Dow's Reservoir and the Realities of Flooding in Texas

Published in the Texas Observer – June 2023
University of Houston – Clear Lake
Faculty Development Week
February 6, 2025

Dow Chemical Harris Reservoir Expansion

Figure 1. New HEC-RAS Cross Section Locations for the Brazos River and Oyster Creek Models

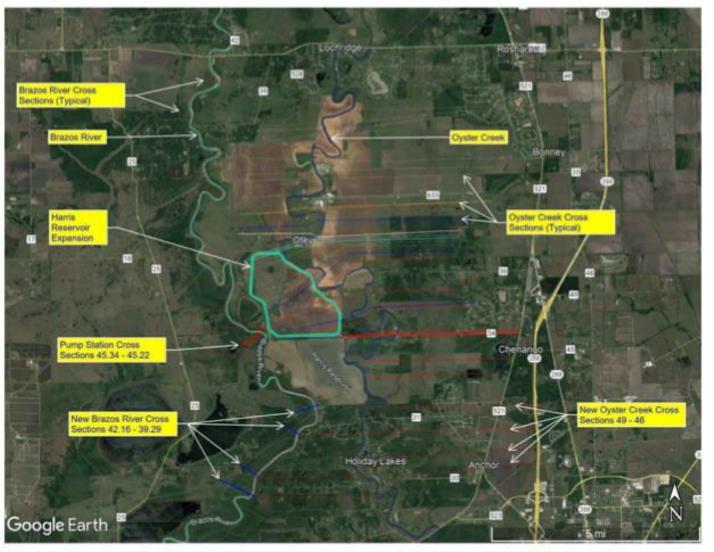
- The Brazos Overflows into Oyster Creek at this Location During Floods
- Submitted Modelling Focused on Localized 100-year Rainfall Event
 - Assumed most rain at the site would fall in the off-channel reservoir and not cause flooding

- Flooding Happens for Weeks at a Time from Upstream Rainfall
 - Not really modeled in hydrology documents in the DEIS
- Submitted Modelling Purportedly Showing No Increase in River Levels Due to the Project Still Had Now-Blocked Overflows Continuing to Occur After Completion

- This Took Some Deep Digging to Confirm
 - Did Not Reflect Reality
